Access Compliance Report

Public Rights-of-Way (Curb Ramps)

Intersection ID: 25103	Main Street: COTTON_CREEK_DR	Cross Street: SHADOW_POND_LN	Location: S
ADA ID: 35E27509FF2F	Ramp Type: PerpDiag	Initial Pass/Fail: Fail	Overall Compliance: No
		Severity Score: 12.5

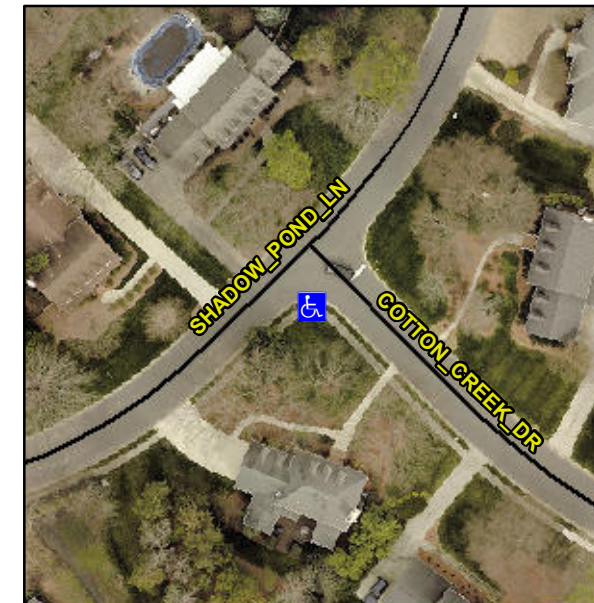
Not Found, R304.2.2

Compliance	Description	Data	Compliance	Description	Data
N/A	Ramp Length (in)	34.5	No	Ramp Slope (%)	8.6
Yes	Ramp Width (in)	48.0	Yes	Ramp XSlope (%)	1.6
N/A	Flare Type LT	N/A	N/A	Flare Type RT	N/A
N/A	Flare Slope LT (%)	N/A	N/A	Flare Slope RT (%)	N/A
N/A	Flare Traversable LT?	N/A	N/A	Flare Traversable RT?	N/A
N/A	Landing Length (in)	N/A	N/A	DWS Provided?	N/A
N/A	Landing Width (in)	N/A	N/A	DWS Contrast?	N/A
N/A	Landing Slope (%)	N/A	N/A	DWS Length (in)	N/A
N/A	Landing X Slope (%)	N/A	N/A	DWS Full Width?	N/A
N/A	Landing Curb? (Y/N)	N/A	N/A	DWS Offset (in)	N/A
N/A	Shared Landing?	N/A			
N/A	Gutter Ponding?	N/A	N/A	Gutter Slope (%)	N/A
N/A	Gutter Lip Ht (in)	N/A	N/A	Gutter X Slope (%)	N/A
N/A	Painted X Walk1?	No	N/A	Painted X Walk2?	No
	X Walk 1 Direction	To NE		X Walk 2 Direction	To NW
N/A	X Walk 1 Width (in)	N/A	N/A	X Walk 2 Width (in)	N/A
	X Walk 1 Slope (%)	4.5		X Walk 2 Slope (%)	2.1
	X Walk 1 X Slope (%)	0.2		X Walk 2 X Slope (%)	1.9

Remove & Replace Curb Ramp With Two New Directional Ramps or Equivalent.
